Yuba Community College District  
3301 E. Onstott Road  
Yuba Ca 95991

Subject: Woodland Community College Synthetic Soccer Field Construction  
Turf Field RFP  
Yuba Community College District

Date: May 7, 2025

#### ADDENDUM NO. 4

SHEET NO.  
L11.1 OF SHEETS

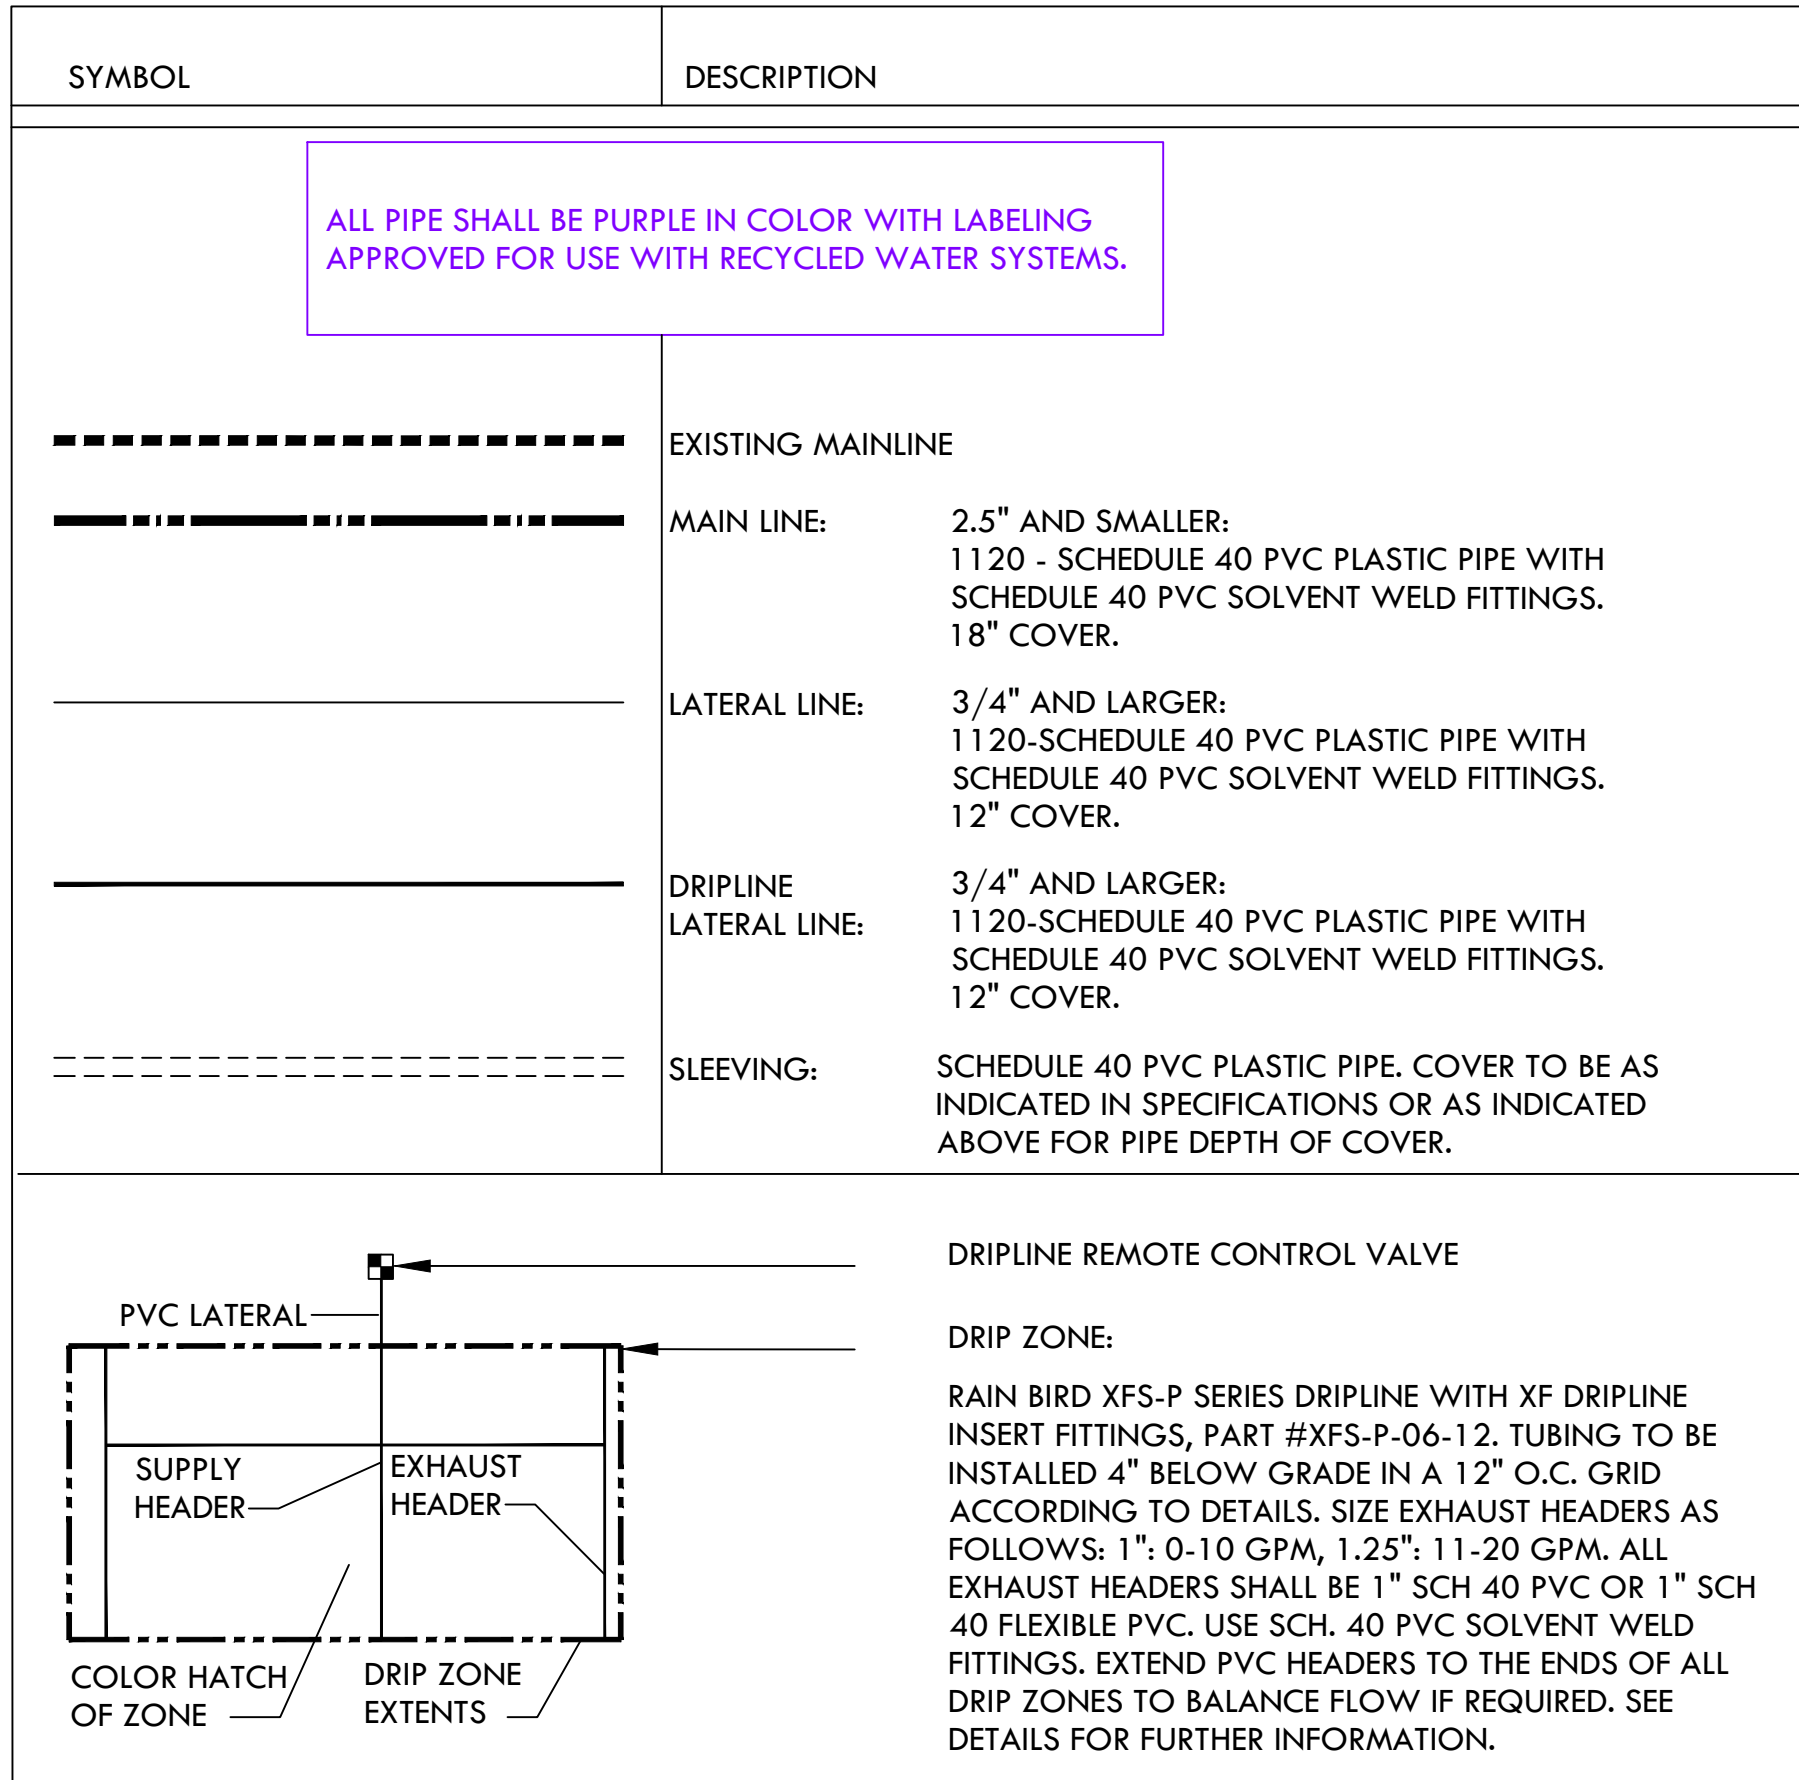
- Questions #7      *Refer to legend on sheet L11.1, the controller has 12 stations, however there are total 19 EA remote control valves. Please confirm if the modular is required to have enough capacity.*

- Answer #7      Please see attached updated drawing with updated controller information.

LCT-22SS316	LEEMCO STAINLESS STEEL CURB STOP VALVE			
	LGT-XX-SS316X	LEEMCO STAINLESS STEEL GATE VALVE (LINE SIZE)-2.5" AND SMALLER			
	ESP12LXMMSSPED/ ESPLXMSM12(11)/NCC-GP	RAIN BIRD ESP-LXME 24 STATION CONTROLLER IN A PEDISTAL MOUNTED ENCLOSURE WITH IQ CELL MODEM.			
	WR2-RFC	RAIN BIRD WIRELESS RAIN/FREEZE SENSOR			
		CONTROLLER AND STATION NUMBER			
		AREA (SQ. FT.)			
		FLOW (GPM)			
		REMOTE CONTROL VALVE SIZE (IN INCHES)			
		ASSOCIATED REMOTE CONTROL VALVE			
		CONTROLLER AND STATION NUMBER			
		AREA (SQ. FT.)			
		FLOW (GPM)			
		REMOTE CONTROL VALVE SIZE (IN INCHES)			
		ASSOCIATED REMOTE CONTROL VALVE
